**FRONT BRAKE CALIPER MOUNTING BOLTS / XL, XLCH, XLT, FX, FXE**

An unknown number of substandard front brake caliper assembly bolts, part No. 3453, were used in 1975 to early 1977 XL/XLCH/XLT/FX and FXE motorcycles.

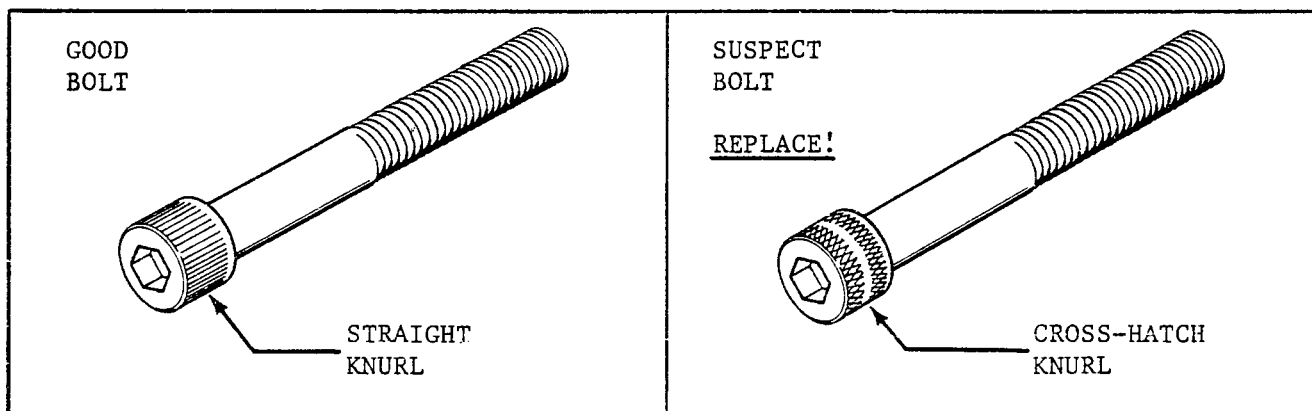
Because of low endurance strength of the bolt material, the suspect bolts may fail after a period of service. It is possible that the broken off portion of such a bolt could work out into the rotating spokes. There is also a remote possibility that both caliper assembly bolts could break and allow the inner caliper half to become detached from the motorcycle. The resulting wheel or brake damage could cause loss of control of the motorcycle and possible motorcycle crash.

The corrective action consists of inspection of the caliper bolts and replacing them where required. The suspect inferior bolts are identifiable by the type of knurl on the outside circumference of the bolt head socket as shown below.

Remove one caliper bolt at a time leaving the other one in place until the first bolt is taken care of. This will keep the caliper halves in correct position. Inspect bolts visually for damage and correct type. Reinstall only STRAIGHT knurled type bolts reusing the washer and nut. Tighten bolts to correct 11 ft. lb. (130 in. lb.) torque. After assembly is completed, check front brake for correct operation. See the service manual for further front brake information if required.

Check your stock of part No. 3453 and return any suspect bolts with cross-hatch knurls to the factory for credit on properly completed warranty claimform.
